ECSI No. 84
September 11, 2019
Gasco Sediments Cleanup Action

Revised Pre-Remedial Design Data Gaps Work Plan

Prepared for U.S. Environmental Protection Agency, Region 10

Anchor QEA, LLC
6720 SW Macadam Avenue
Suite 125
Portland, Oregon 97219

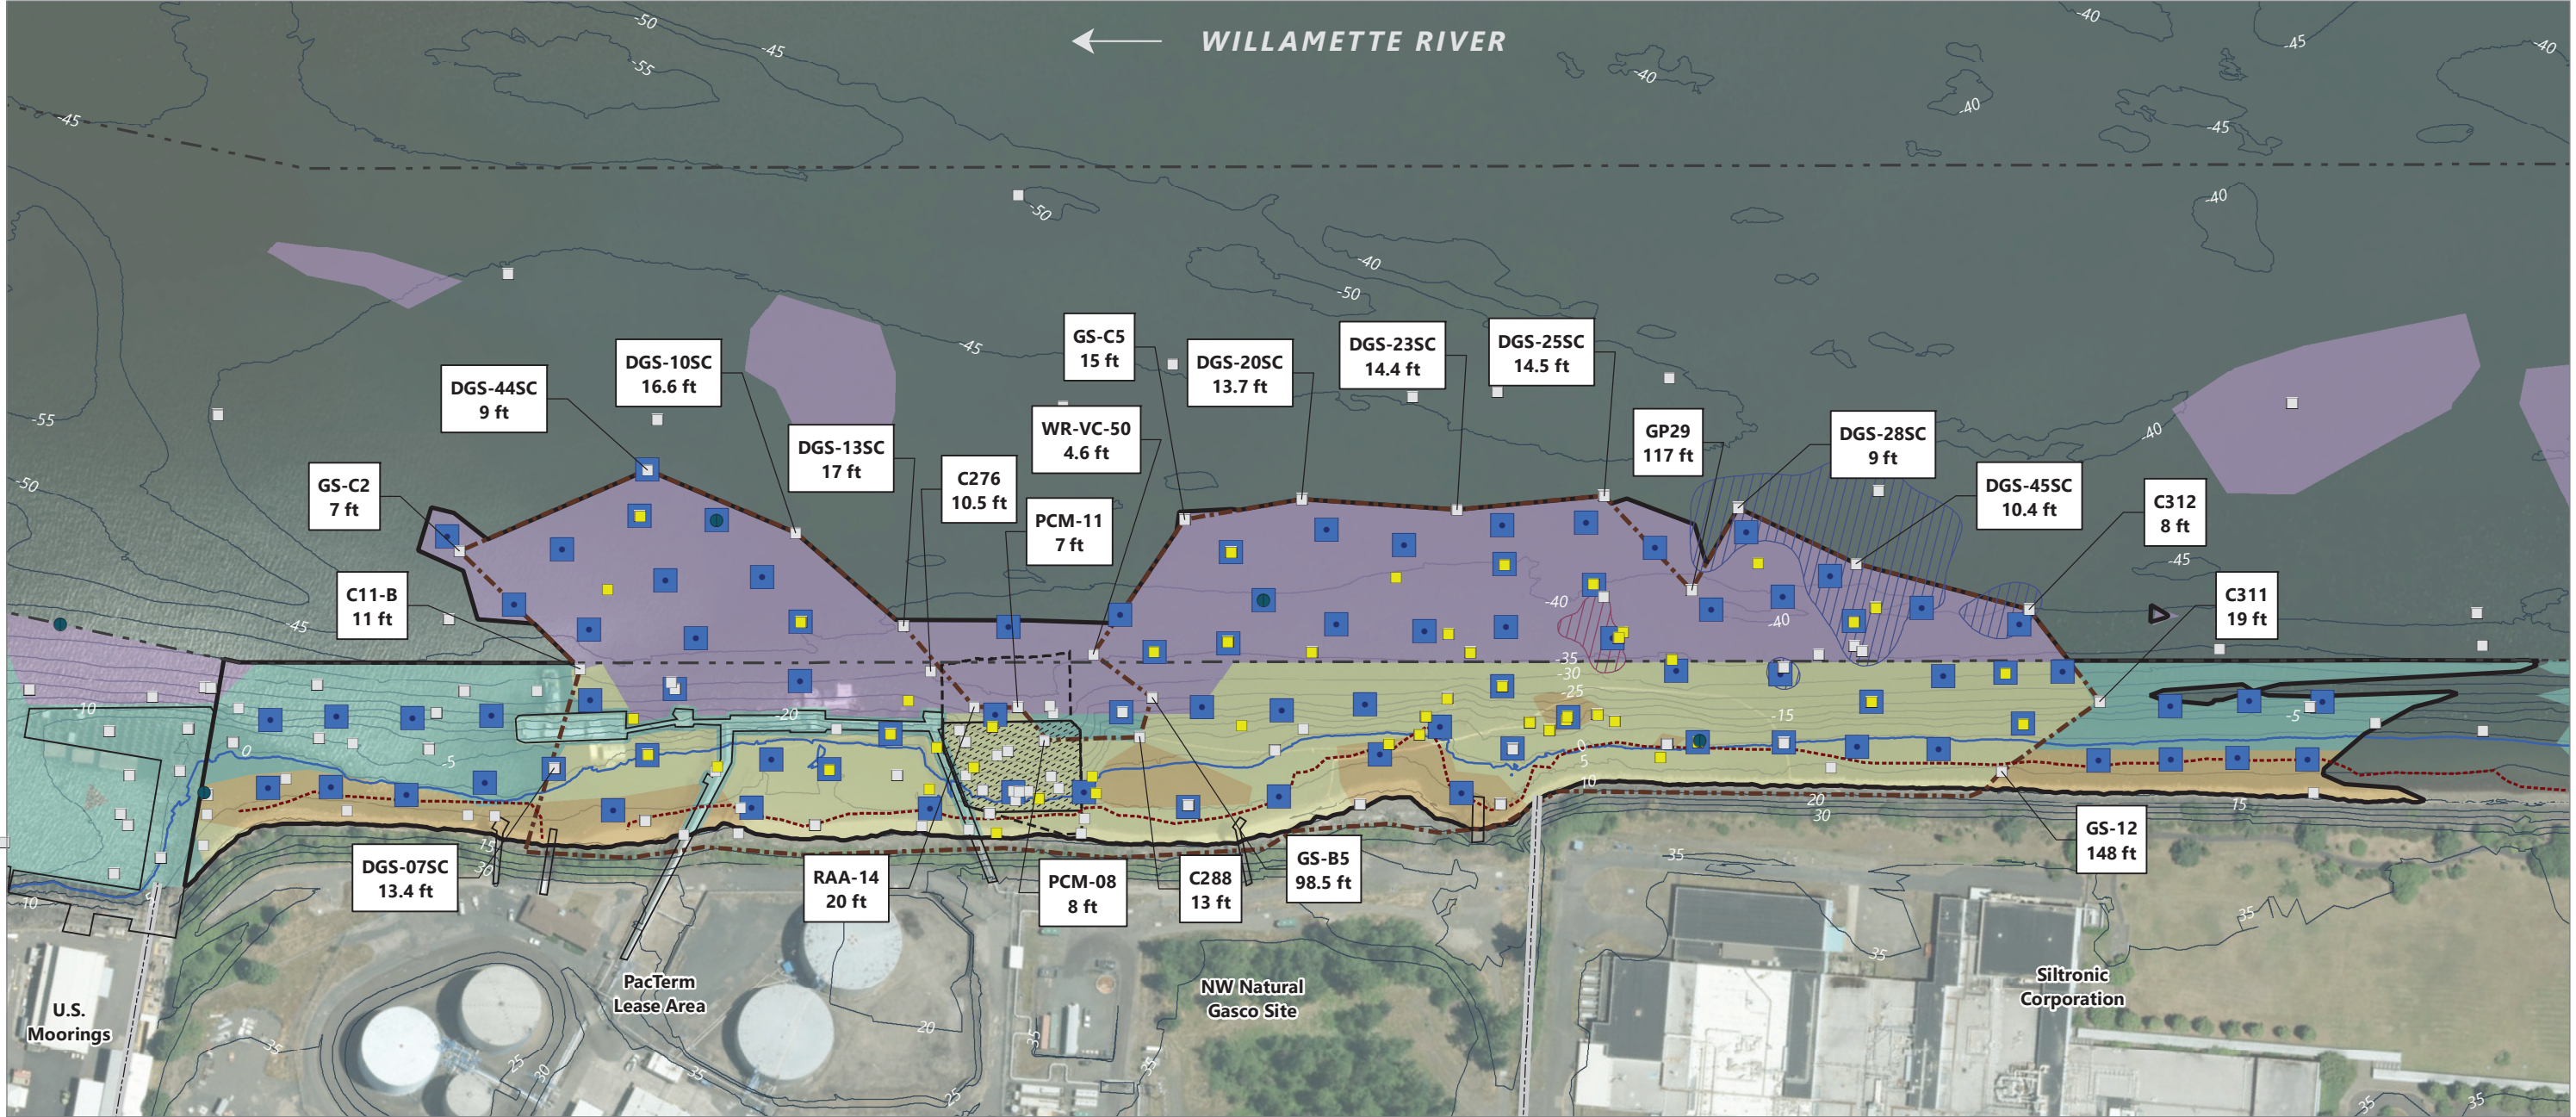
118. **Addendum dated July 3, 2019, Figure 9.** It is unclear from looking at this figure if the armored riverbank at the Siltronic property extends to the upriver end of the Gasco project area. Revise the figure to show the location of the armored rock at the Siltronic riverbank. If the armor stone does not extend across the entire Siltronic riverbank then additional riverbank borings should be collected in this upriver area.
